• SUBJECT: 19EA OIL LOSS

F.E.R. 77-5

To advise the field of recommended troubleshooting techniques and repair procedures concerning 19EA Oil Displacement (Loss) problems.

19EA OIL LOSS

Fig. 8

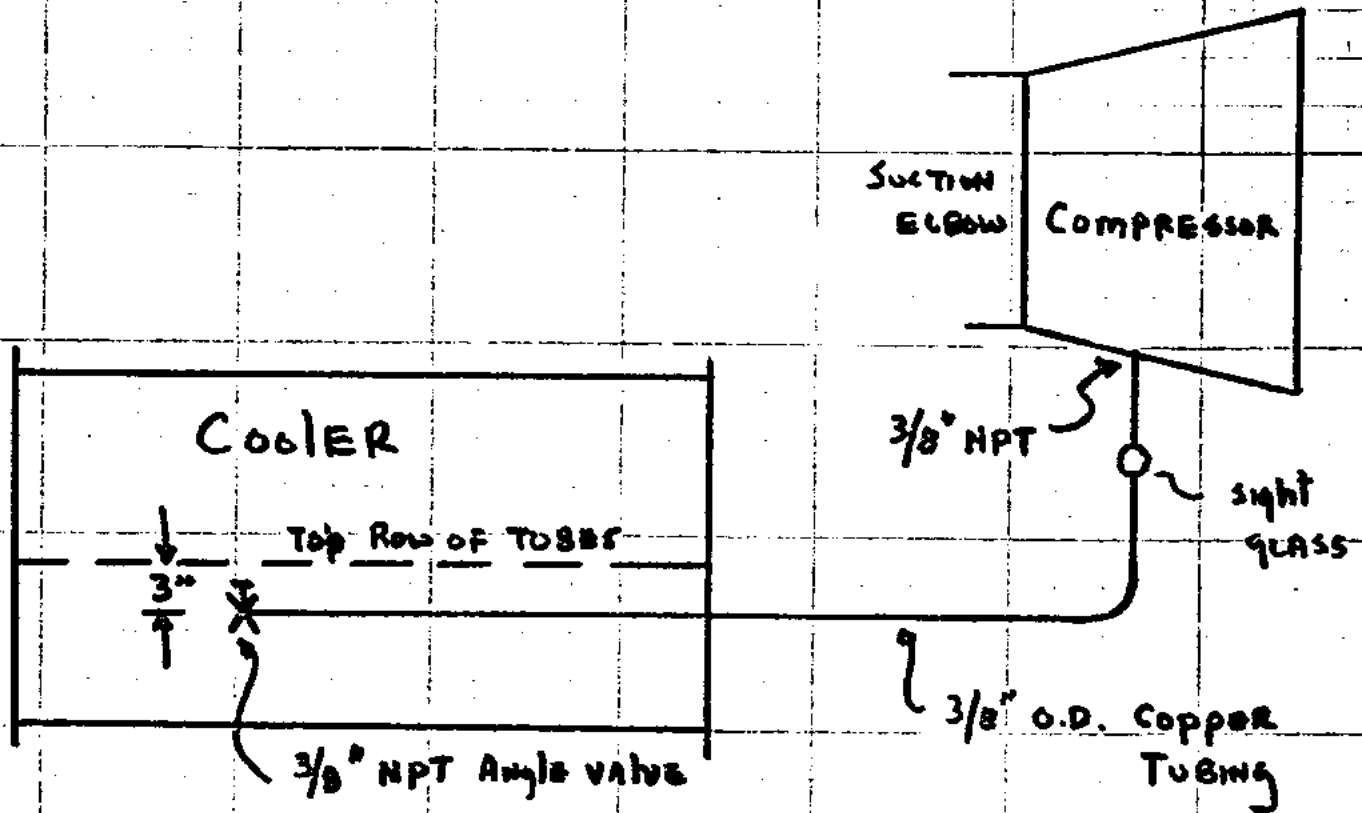
6.2.1 Drill and tap a 3/8" hole approximately three rows down from the top row of tubes in the cooler. This location is approximately four (4) inches down from the filter-drier return connection. Consult BULLETIN 19SB-76-8E for dimensions.

6.2.2 Drill and tap a 3/8" hole in the downstream side of the inlet guide vanes. This connection is located at the suction of the first stage impeller. CONTACT ZONE SERVICE ENGINEERING for the exact location for this connection since the dimensions between vanes and the impeller differ for different impeller combinations.

6.2.3 Connect these two holes with 3/8" copper tubing. Install a 3/8" angle valve and sightglass in the line so the flow can be controlled. SEE FIGURE 8.
